Access Compliance Report Public Rights-of-Way (Pedestrian Signals)

Intersection ID: N/A	Main Street:	Cross Street: N/A	Location: N/A
ADA ID: 6E1AA80CCF34	Signal Type: One Push Button-Non APS	Overall Compliance: No	Severity Score: BTN 1: N/A BTN 2: N/A No BTN: N/A
Codes/Mitigation Info/Possible Solution		Field Measurements/Component Compliance

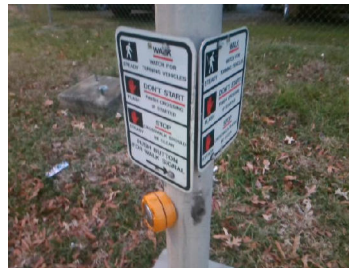
PROW/ADA: TMUTCD 4e.08, R404.3, R406.2

Yes	B 1 Clear Xing Direction?	ClearlyMarked	N/A	B 2 Clear Xing Direction?	N/A
	B 1 Crossing Direction	To NW		B 2 Crossing Direction	N/A
Yes	B 1 DistanceTo XWalk (in)	12.0	N/A	B 2 DistanceTo XWalk (in)	N/A
No	B 1 DistanceTo Curb (in)	83.0	N/A	B 2 DistanceTo Curb (in)	N/A
Yes	B 1 Diameter (in)	2.0	N/A	B 2 Diameter (in)	N/A

Possible Solutions: Replace Signal Push Button With APS Button on New Post. Remove & Relocate Sign.
